(Product Change Notification)

PCN# 040117

DESCRIPTION: M12 MALE - PANEL MOUNT (REAR) - SOLDER CUP - 8 POS.

| DWG NO. | 859-008-103R00Y | | | | | | |

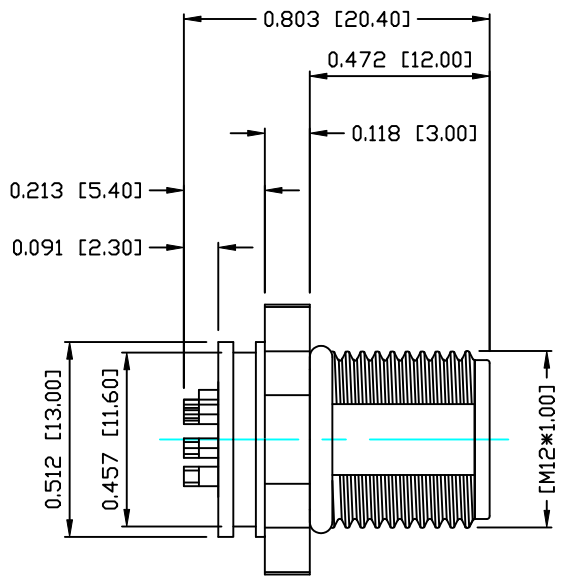
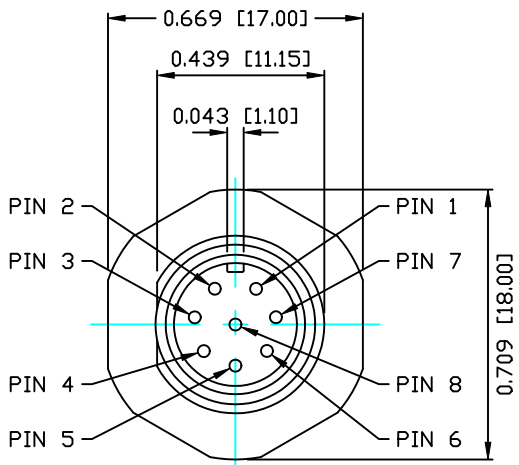
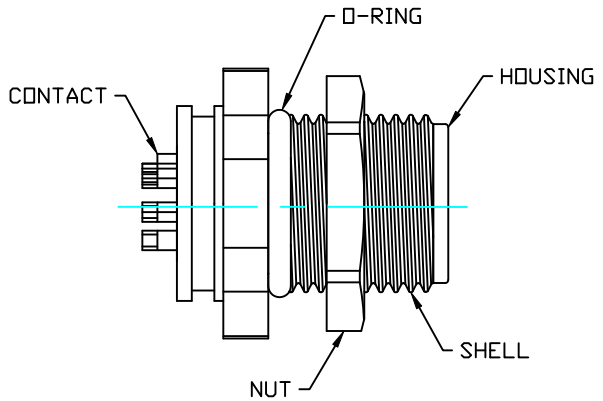
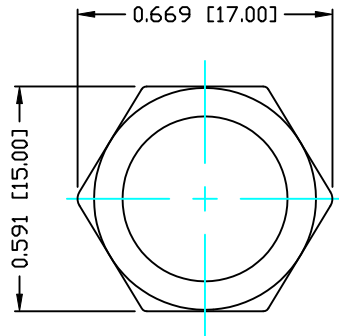
Please be advised NorComp has made a design change to item numbers 859-008-103R001 & 859-008-103R004. Our records show that you have purchased some of these products in the last 5 years. The updated drawing is below and also located on the NorComp web site at www.norcomp.net.

Change Description: Modified the sealing of the connector to enhance the Ingress Protection (IP) properties.
